REQUEST FOR COUNCIL ACTION

AGENDA SECTION: PUBLIC HEARINGS	ORIGINATING DEPT: PLANNING	ITEM NO. E-4
ITEM DESCRIPTION: Amended Preliminary Plat #02-21 to be known as Stonebridge by Exemplar, Inc. Money Purchase Pension Plan. The Plat proposes to subdivide approximately 26.37 acres of land into 67 lots for single family development and 3 outlots. The plat also dedicates the right of way for new public roadways. The applicant is also requesting Design Modification #03-07 to the requirements of Chapter 64 of the <u>Rochester Zoning Ordinance and Land Development Manual</u> to not provide a mid-block pedestrian connection as required in Section 64.227. The property is located along the west side 36 th Avenue SE (County Road 109) and south of College View Road (County Rd. 9).		PREPARED BY: Brent Svenby, Planner

RE: Amended Preliminary Plat #02-21 known as Stonebridge

**RE: Amended Type III, Phase II, Land Subdivision Permit #02-21
(Preliminary Plat) known as Stonebridge.**

PRELIMINARY PLAT

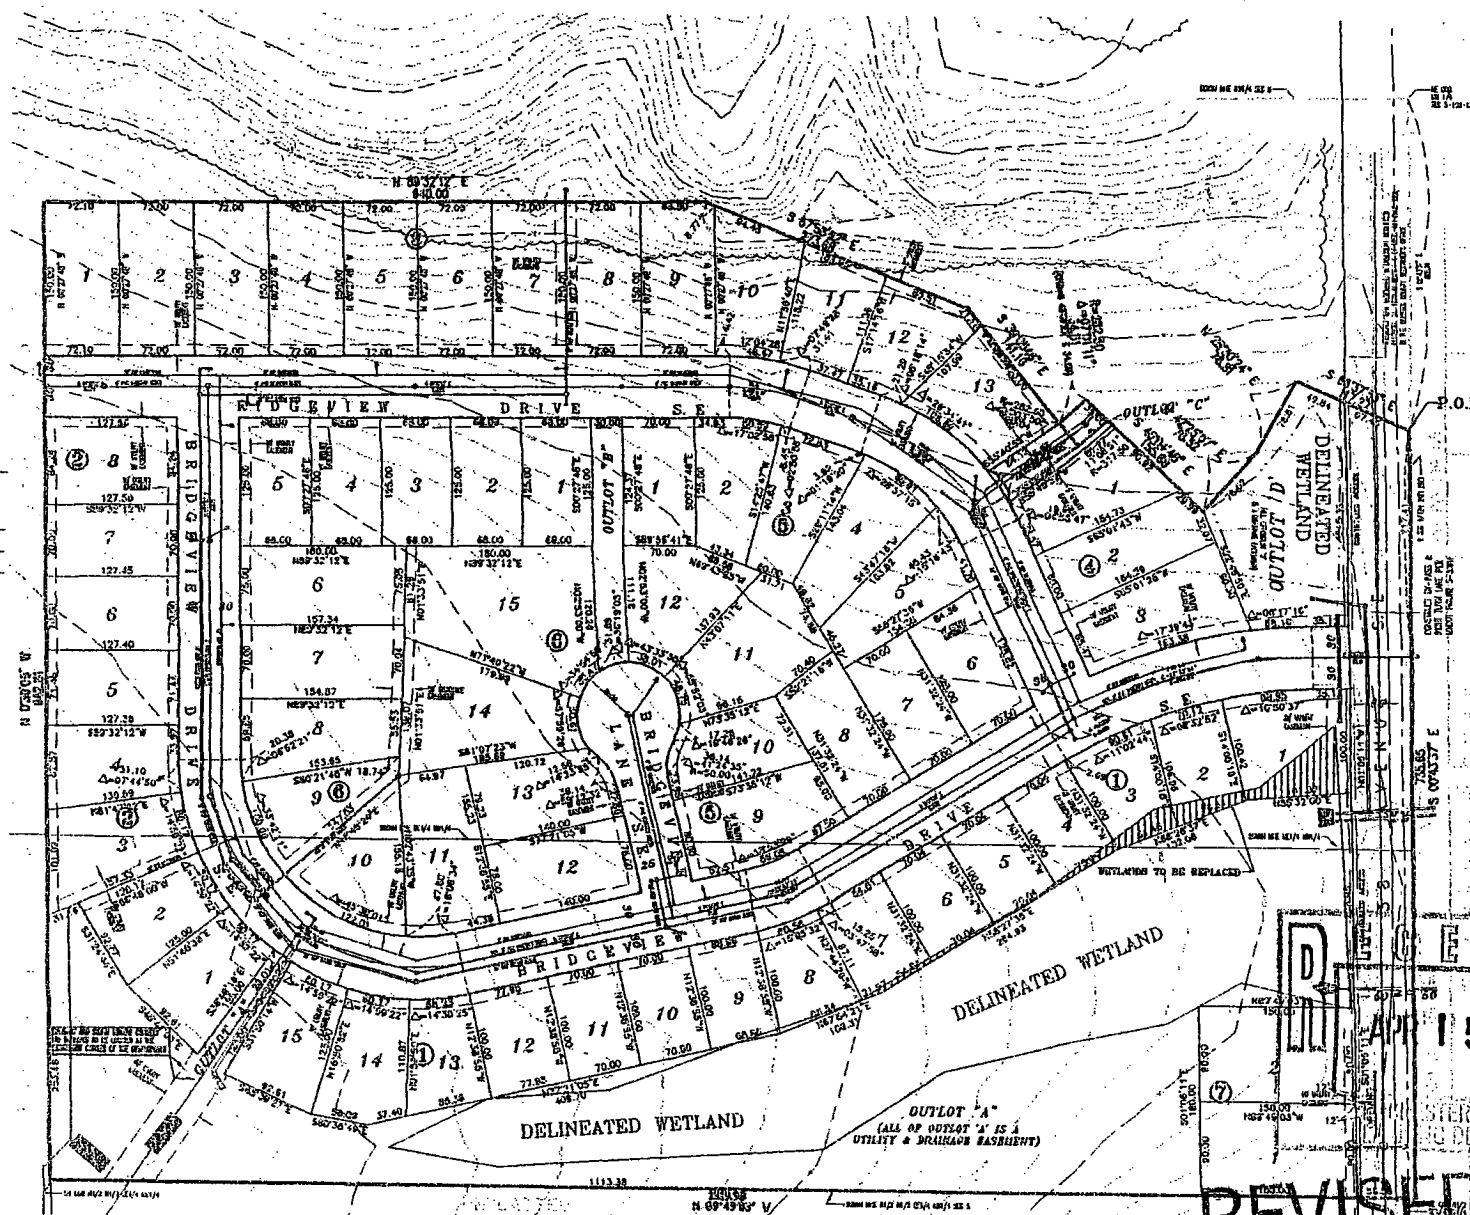
NOTE: A revised plat was submitted on April 15, 2003 addressing condition one so that condition can be stricken. The revised plat also has 13 lots in Block 3 instead of 12 lots shown on the previous plat.

1. The plat be revised to include the following:

- Outlot B be 30 feet in width
- Outlot A be 30 feet in width
- Identify controlled access along County Road 109 except for the public roadway connection and the shared driveway for Lot 1 & 2, Block 7.

- Identify controlled access within 35 feet of the intersection of County Road 109 and Bridgeview Drive SE, along the south line of Outlot D and the north line of Lot 1, Block 1.

- A 30 feet wide mid-block pedestrian connection be provided in Block 3, possibility between lots 6 & 7.
2. Prior to the submittal of the final plat, the applicant shall enter into a development agreement with the City that outlines the obligations of the applicant relating to, but not limited to, substandard street reconstruction charges, stormwater management, park dedication, traffic improvements, pedestrian facilities, right-of-way dedication, controlled access and extension of utilities for adjacent properties and contribution for public infrastructure.

9. A portion of the Delineated Wetland indicated on the Preliminary Plat is hashed, and labeled "Wetlands To Be Replaced", however, it appears that based on the reconfiguration of lots in Block 1, a significant area of the wetlands to be replaced are not impacted by this development. Furthermore, the most recent revised Construction Plans show the entire Delineated Wetland hashed and labeled "Do Not Grade In Delineated Wetland". It should be clarified whether or not wetland replacement is still applicable for this project. If the wetlands are no longer going to be impacted and replaced, clarification is needed to address how the wetland areas within platted building lots be protected.

GRADING PLAN
STONEBRIDGE
ROCHESTER, MN

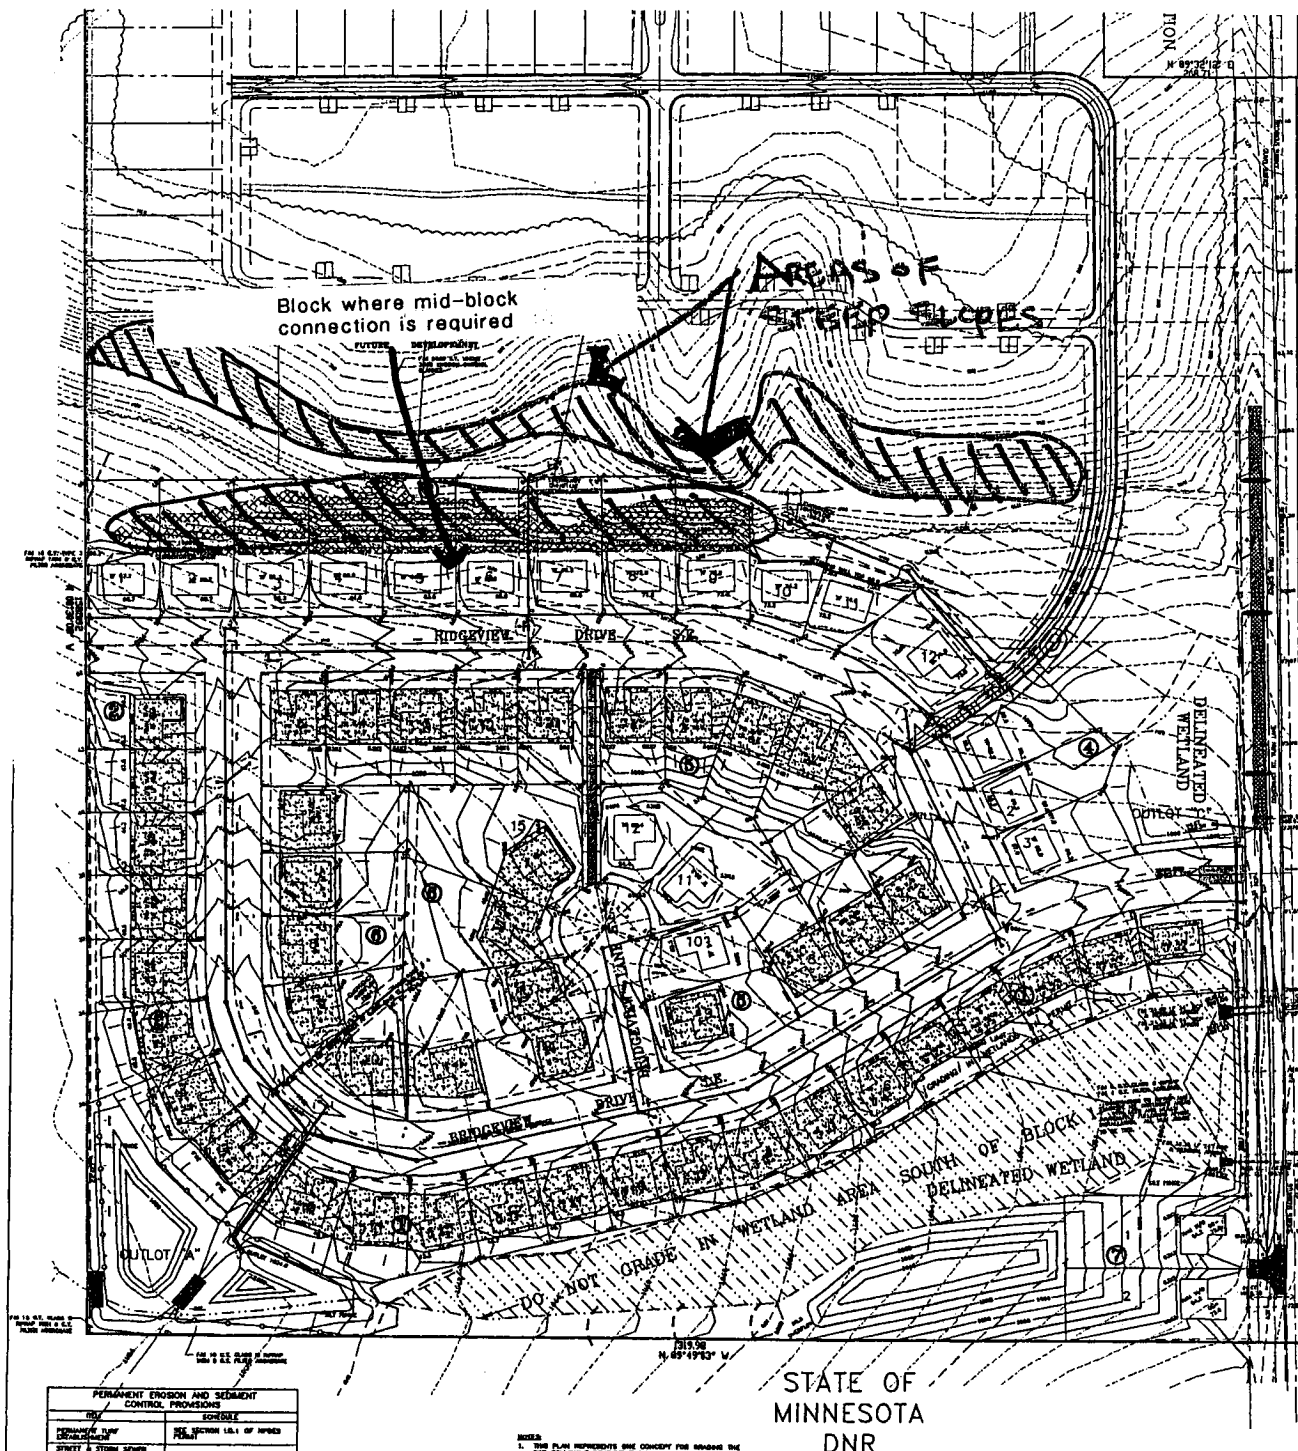
The preliminary plat of "**Stonebridge**" shows the length of Block 3 exceeding 800 feet in length, therefore a mid-block sidewalk or trail is required.

The applicant's consultant has provided information indicating that the area to the north of the required mid-block pedestrian connection contains slopes in excess of 20%. In addition the area to the north will be private recreation space maintained by a homeowner's association for the single attached housing that is planned for the area to the north. These slopes do not favor the construction, maintenance or use of pedestrian facilities.

The area directly to the north of the required mid-block connection contains slopes in excess of 20%. We do not feel these slopes would be appropriate for pedestrian facilities to be built on. The attached drawing shows the area of steep slopes where the pedestrian connection is required.

Staff recommends that the Council approve the requested design modification and not require the mid-block connection as recommended in the staff report.
